I-285@ CR 4519/Atlanta Road

GDOT Project Number: STP00-0222-01(001), P.I. No. 752300

Value Engineering Study Report

June 2009

B2-1

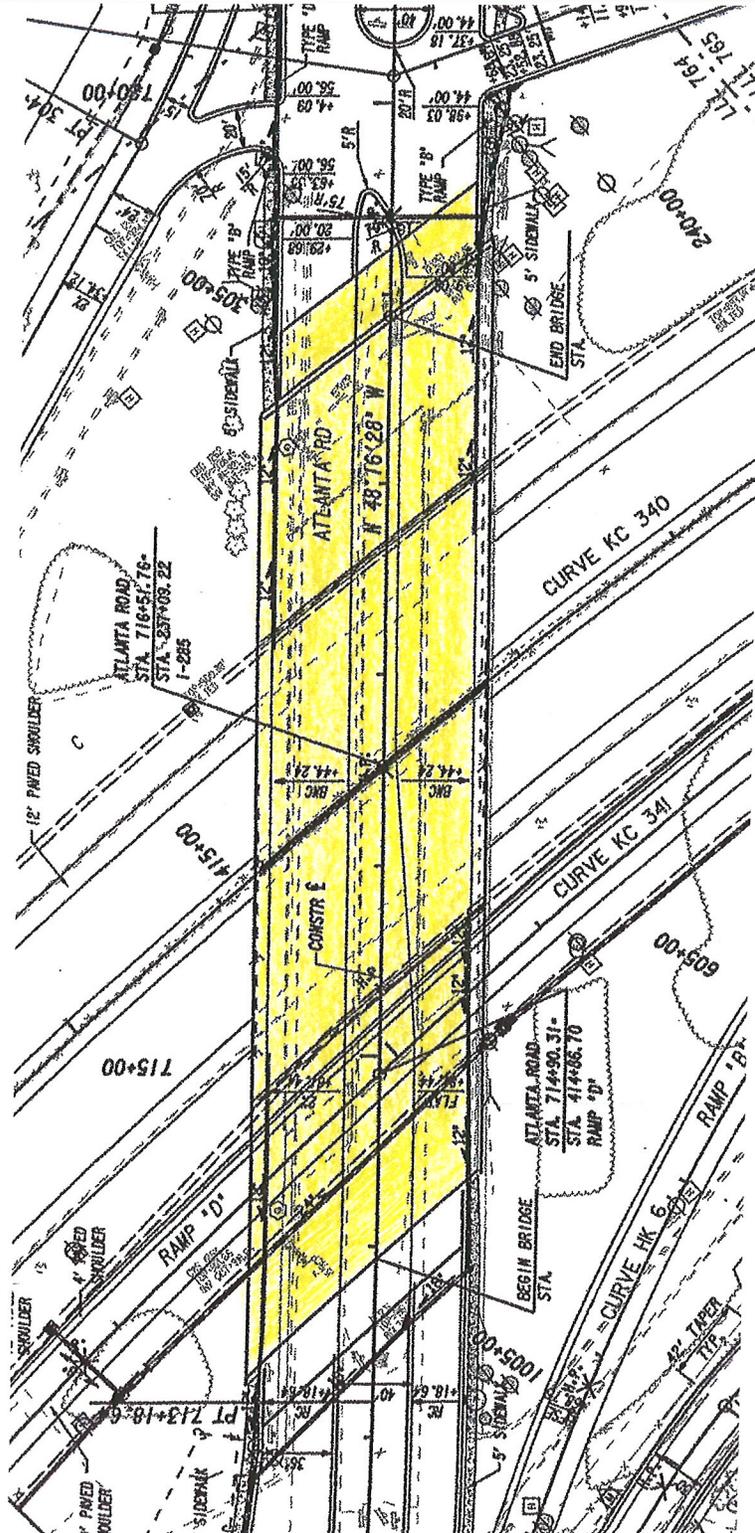
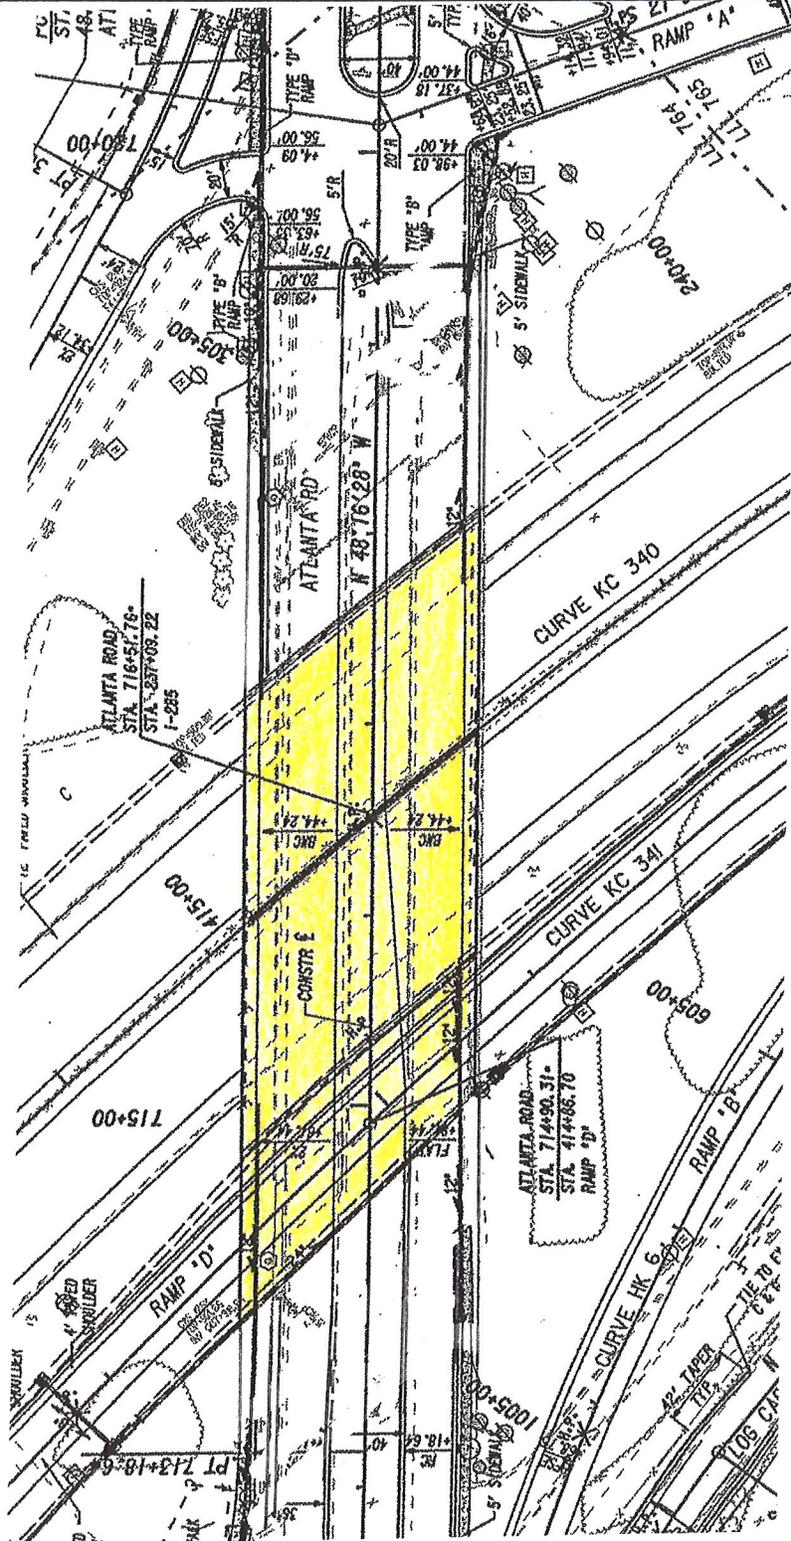
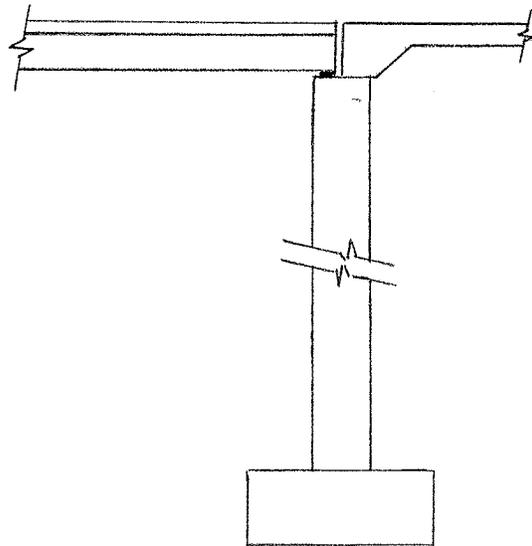
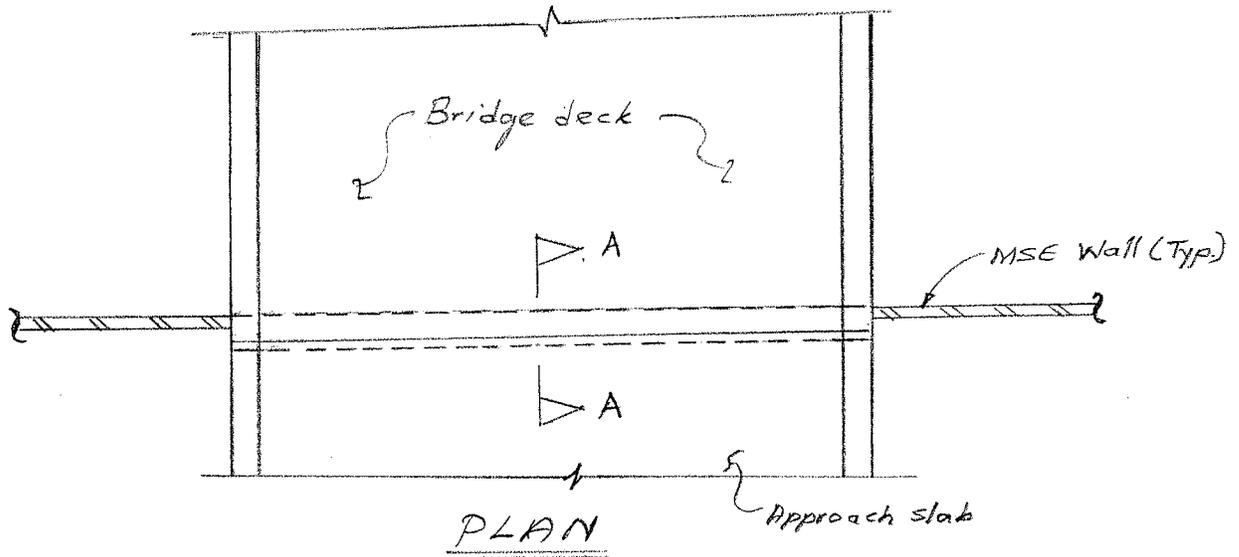
The original design for the Atlanta Road bridge over I-285 is a 504.4-ft-long, prestressed concrete beam bridge and 118.42 ft wide. The bridge spans over eight lanes on I-285, proposed Ramp D and future expansion lanes including five collector-distributor and five through lanes in each direction.

Provide a 384.4 ft-long-bridge that will span over the eight lanes existing lanes of I-285 and proposed Ramp D without the future five southbound collector-distributor lanes. In the future, the proposed end bent will be converted to an intermediate bent to accommodate additional lanes. Mechanically stabilized earth (MSE) walls will be used along the temporary end bent to retain soil.

The use of earth-fill and shortening of the bridge will reduce the cost of construction by \$885,603. Time of construction will also be reduced. The benefit to this approach is that it is unknown when or if I-285 will be expanded to ten lanes in each direction. If the probability of this occurring is greater than 10 years, then constructing extra structure that will provide no benefit for traffic operations for 10 or more years does not provide good value. In fact, constructing the extra span now costs more because it must be inspected and maintained and its useful life will be reduced.

ALT. No.
B-28
Sht. 2 of 6

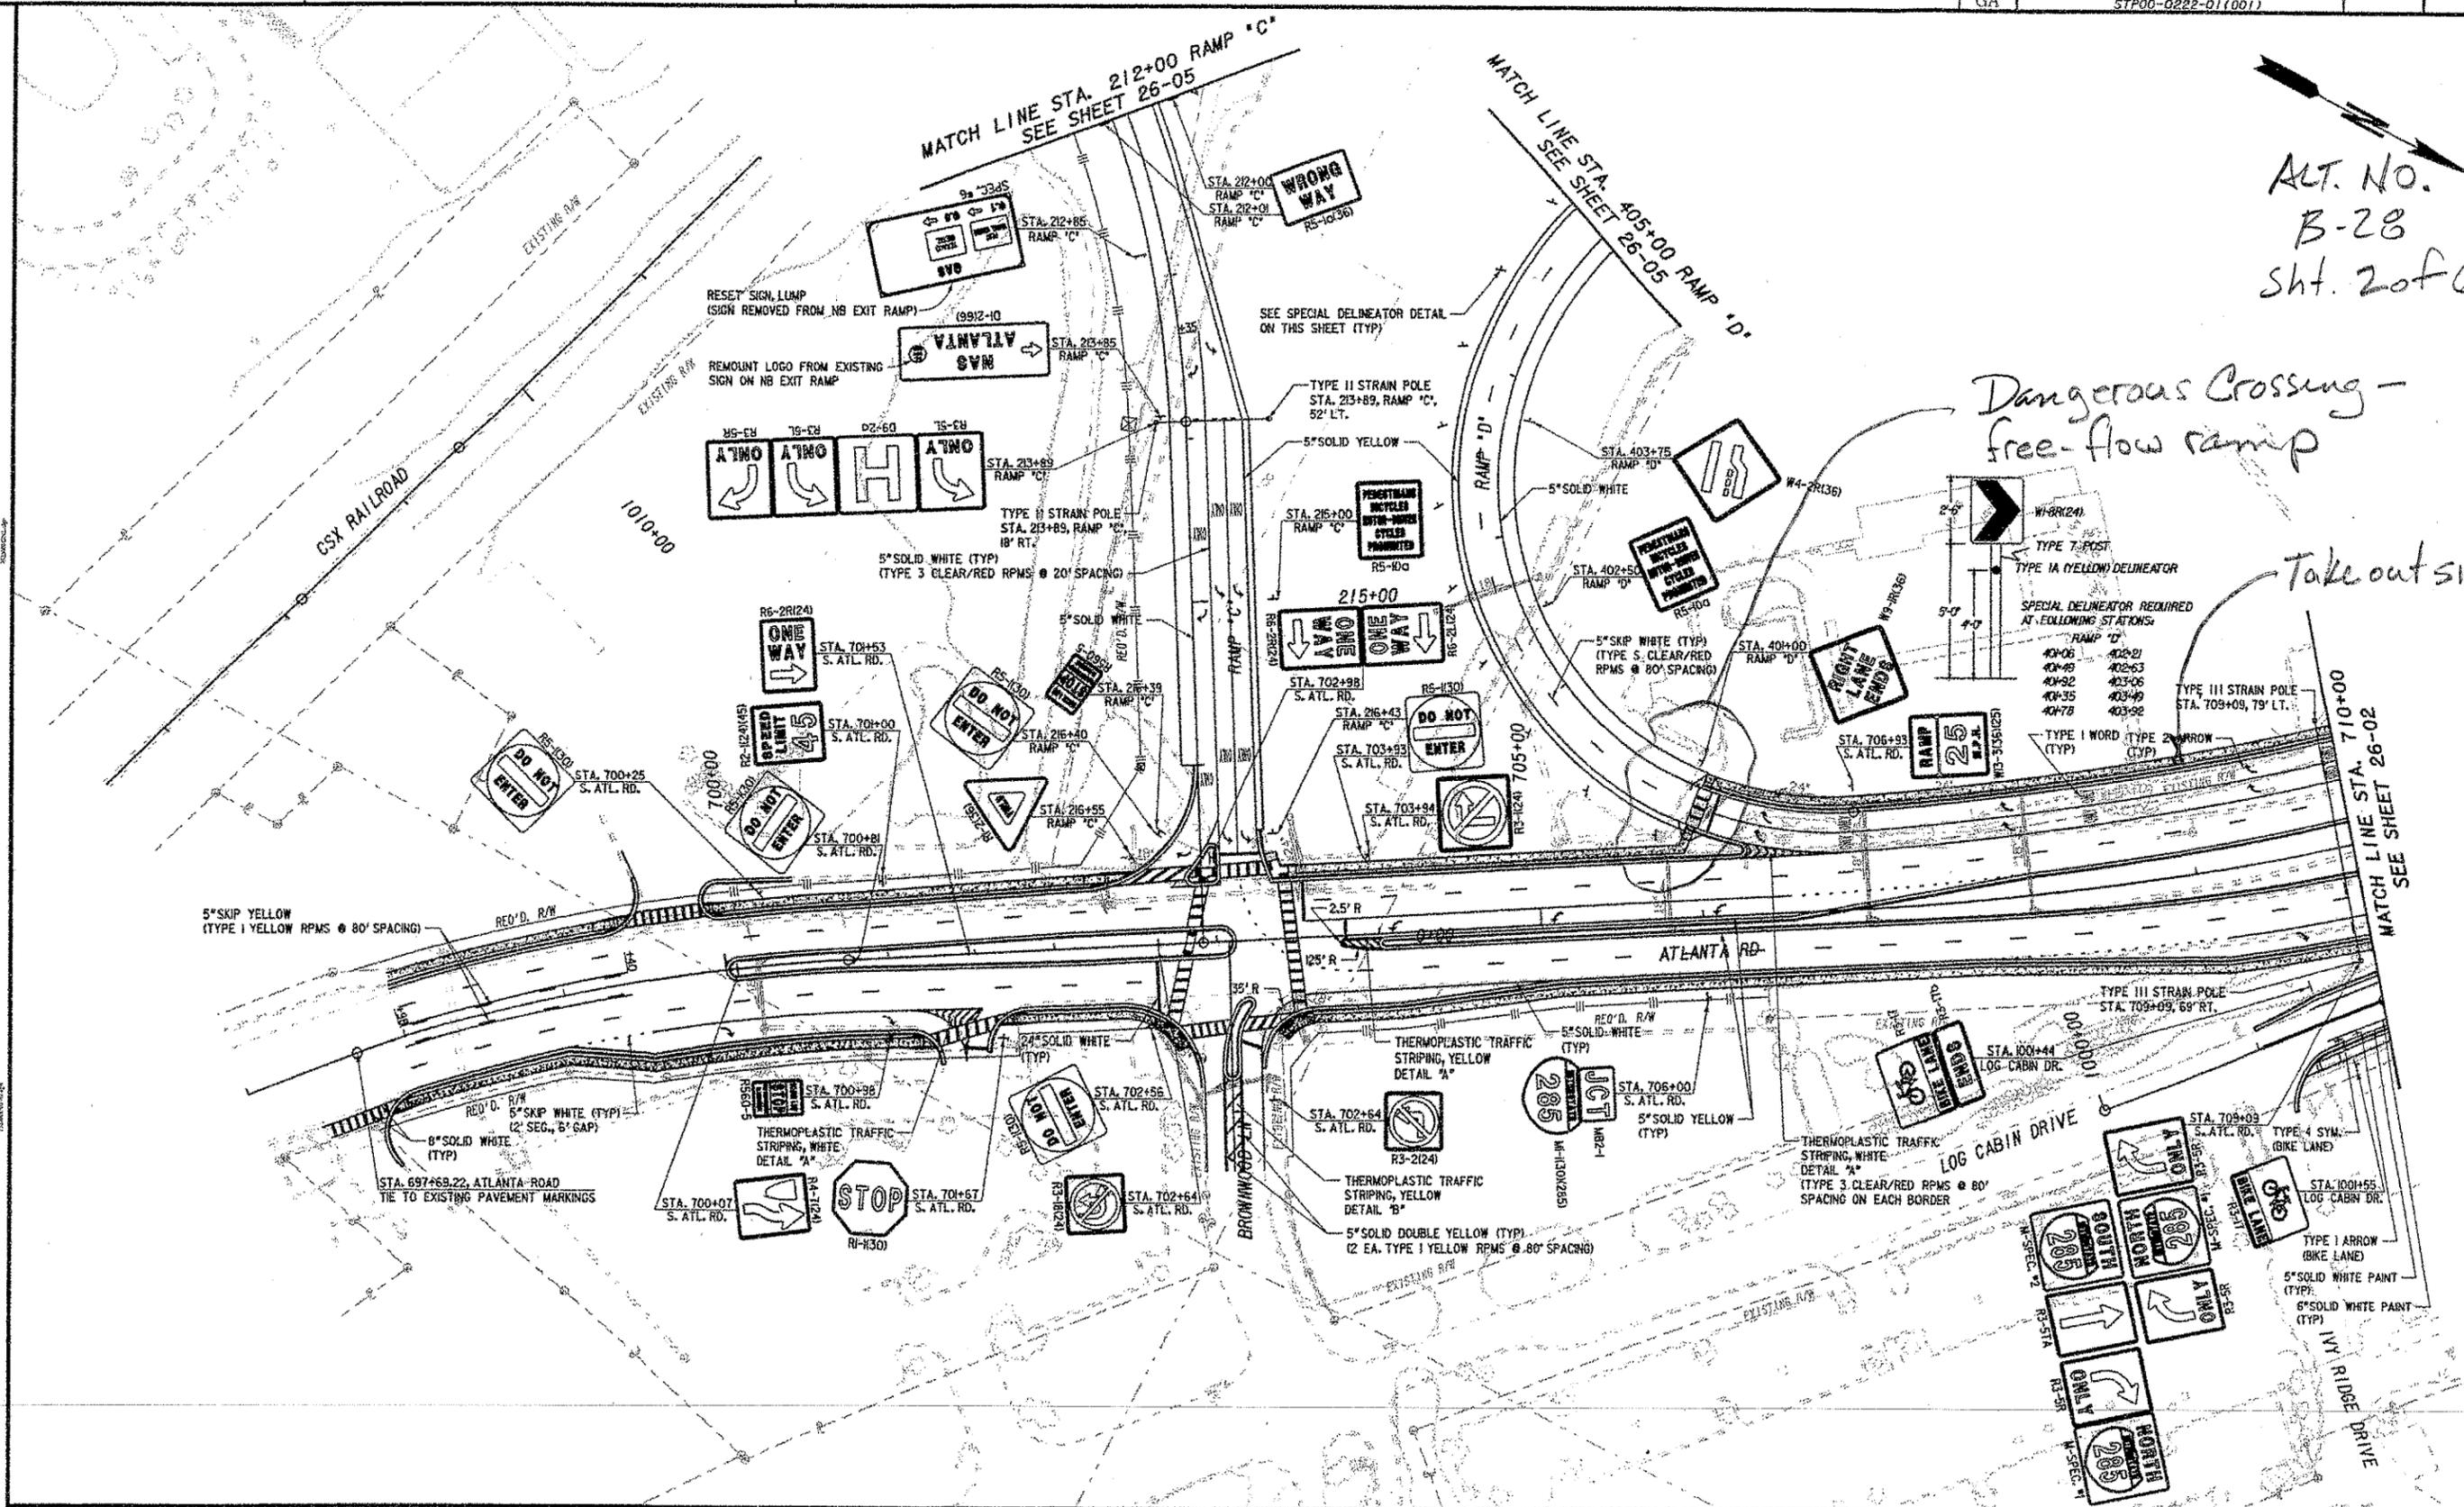
Dangerous Crossing -
free-flow ramp

Take out sidewalk

ALT. NO.
B2-8
Sht 3 of 6

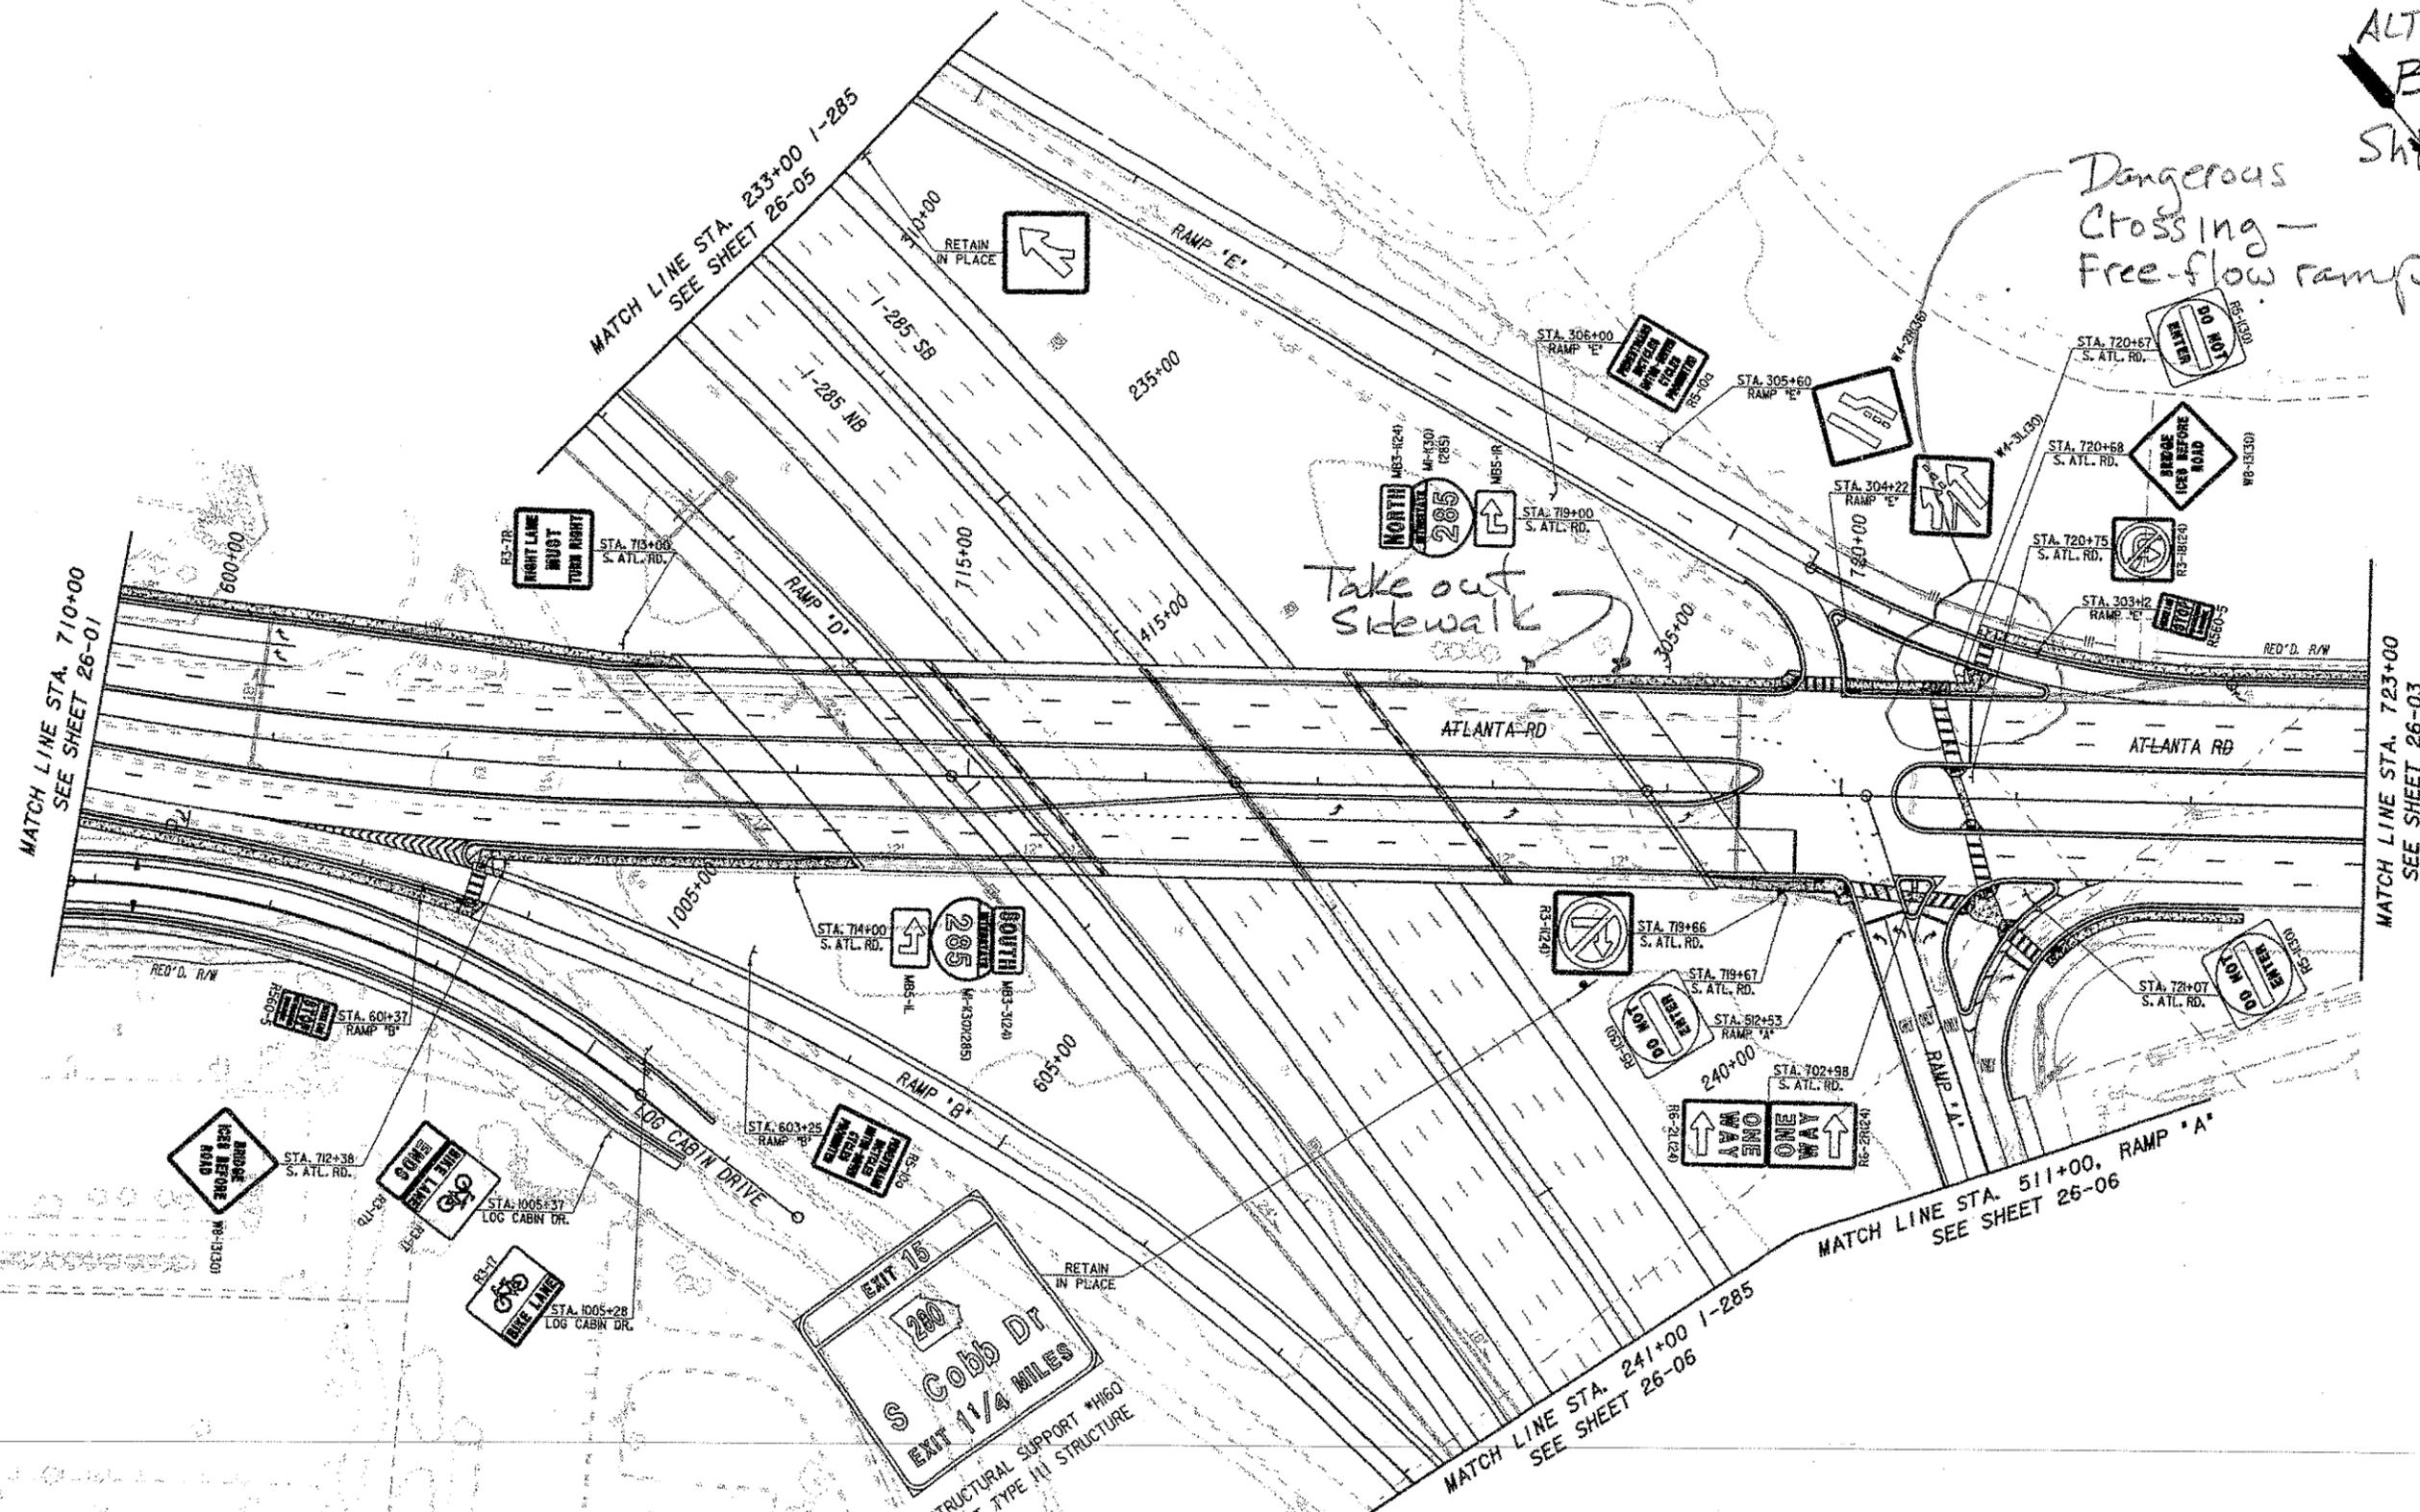
Dangerous
Crossing -
Free-flow ramp

Take out
sidewalk
